Case # BZA-07-25-00883

Charleston County BZA Meeting of September 8, 2025

Property Location: 3555 Bohicket Road – Johns Island

Request: Variance request for an access drive that is

SITE PLANS

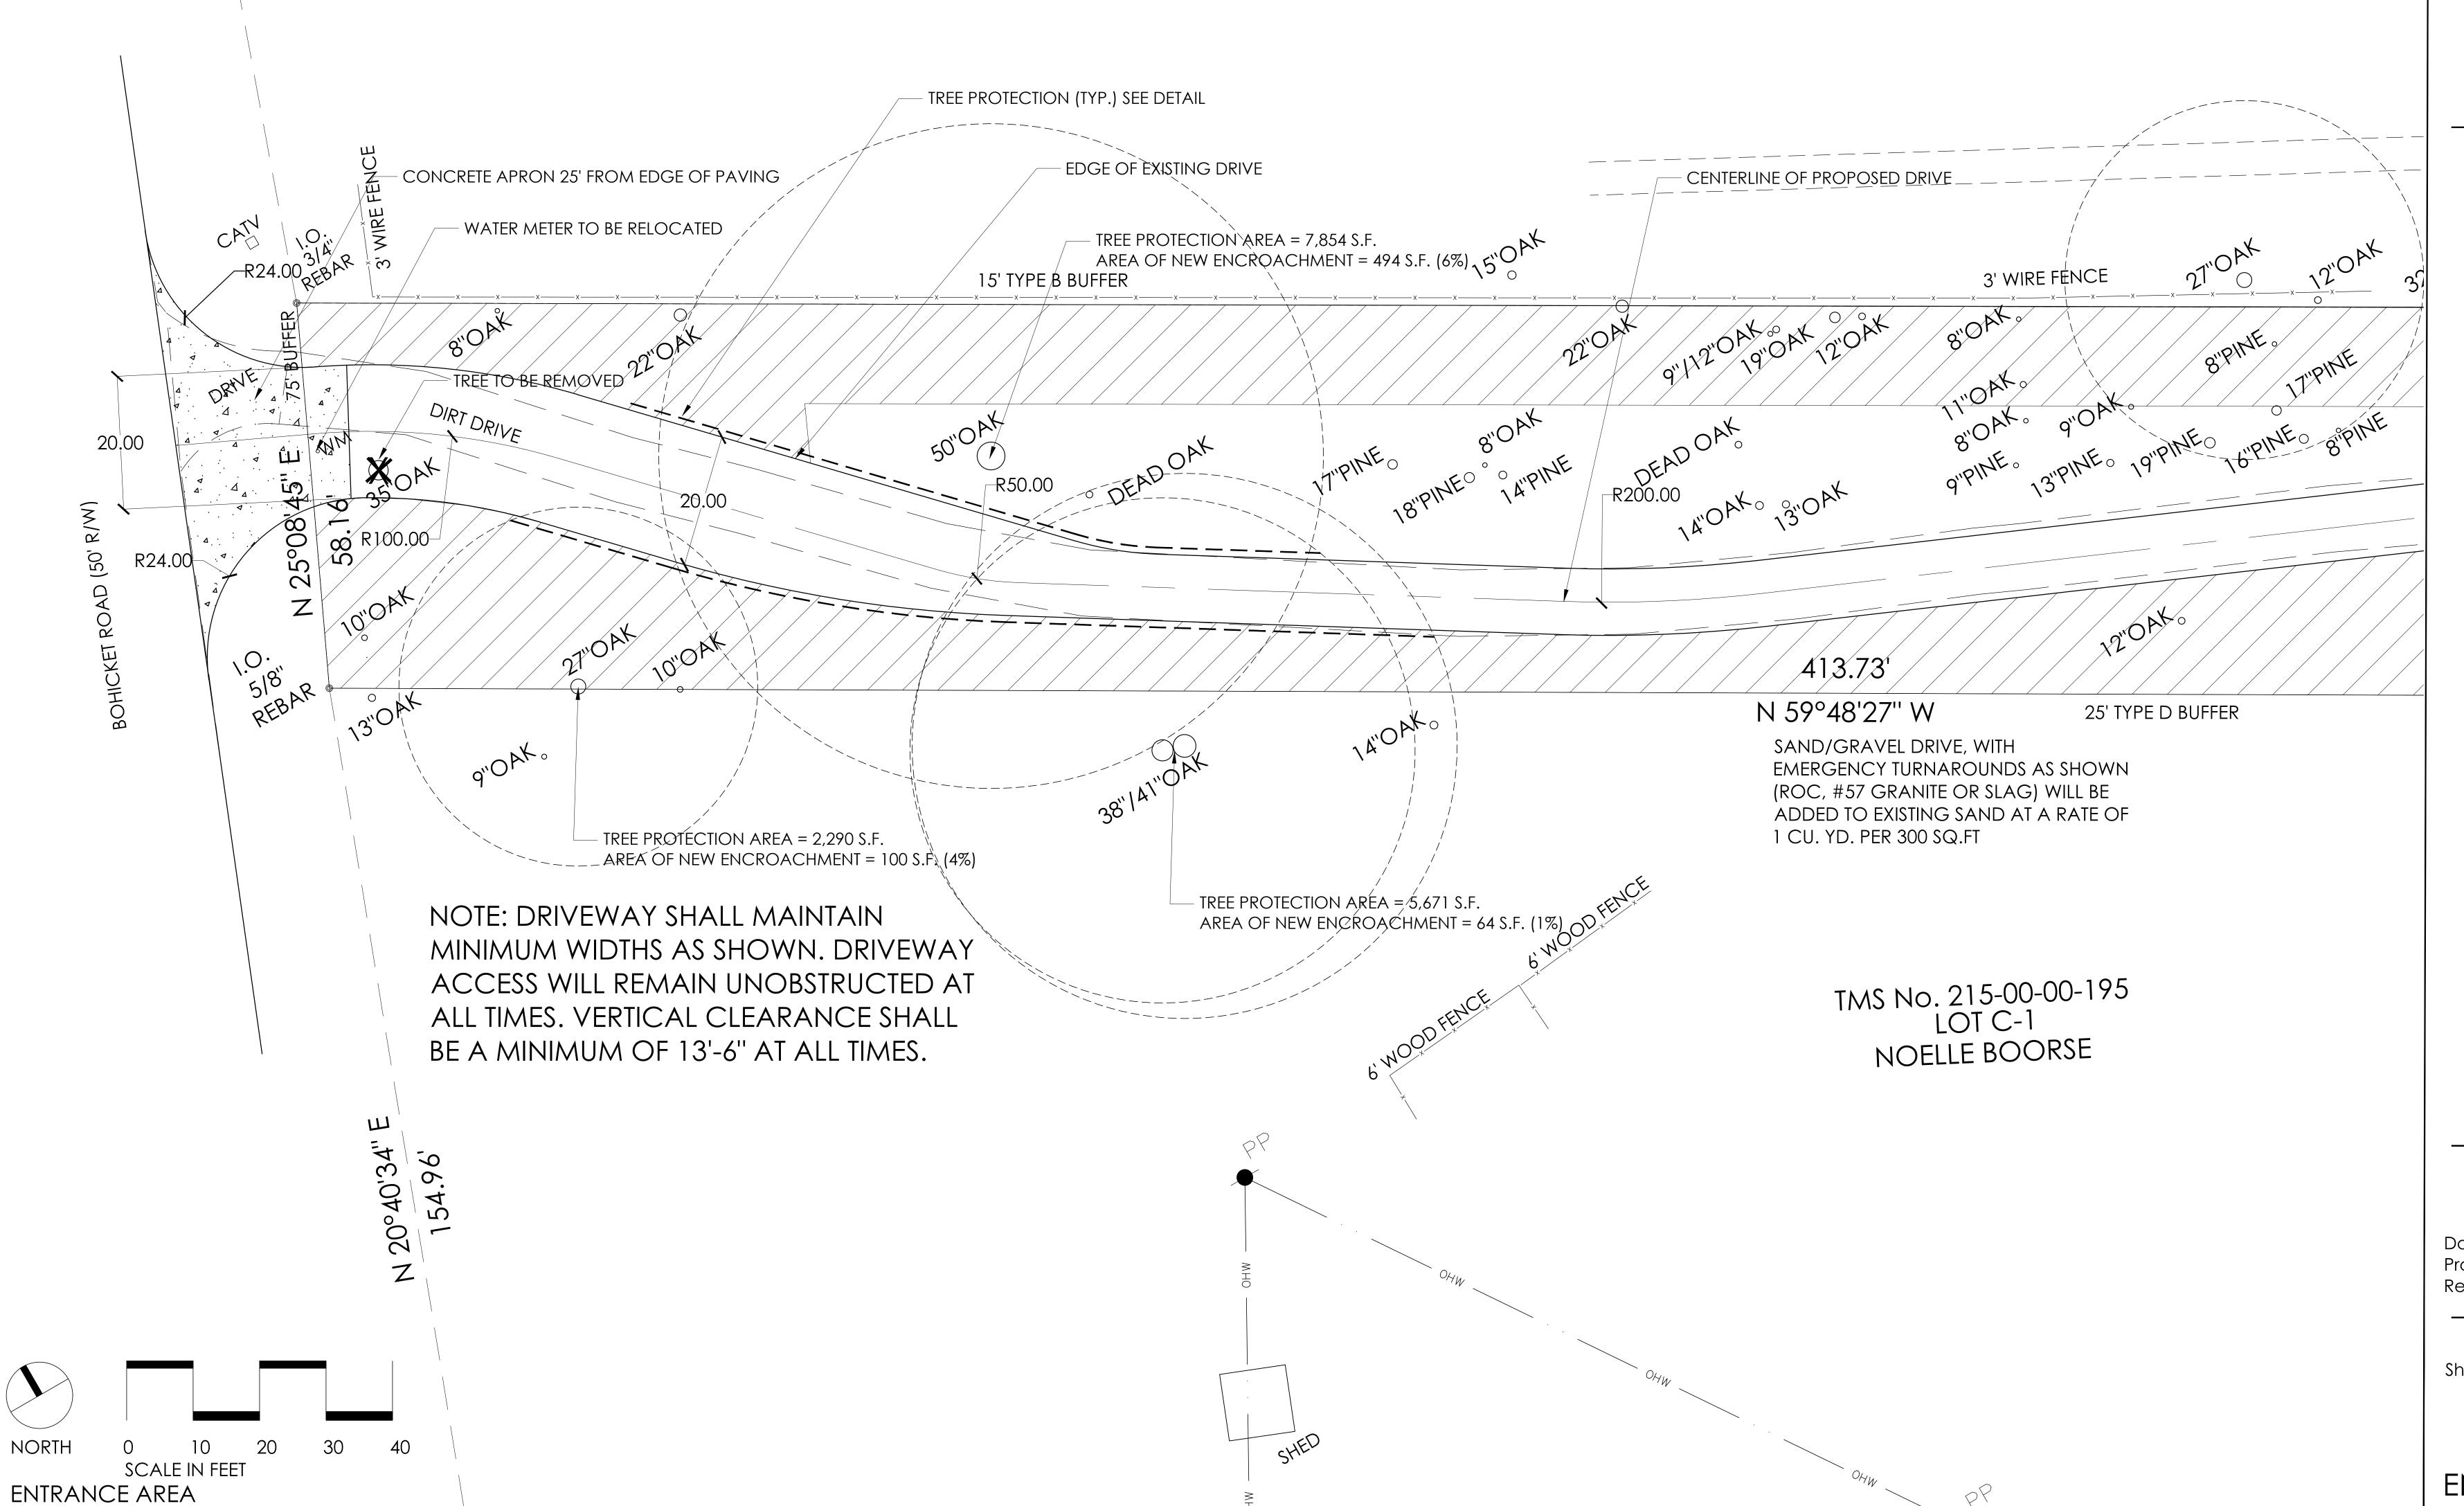
Thank you for the opportunity to review your proposal for the property at 3555 Bohicket Road. After assessing the submitted plans, we have determined that they do not fully meet the requirements of the 2021 International Fire Code (IFC).

While we will allow the project to proceed with the current width clearance, please ensure a height clearance of 13 feet 6 inches, as required by code. Additionally, please note that the business must be within 500 feet of a fire hydrant if it is not equipped with a sprinkler system, or 600 feet if it is.

We also ask that you adhere to the 2021 IFC requirements for turnaround dimensions for emergency vehicles and consider increasing the entrance width for improved accessibility.
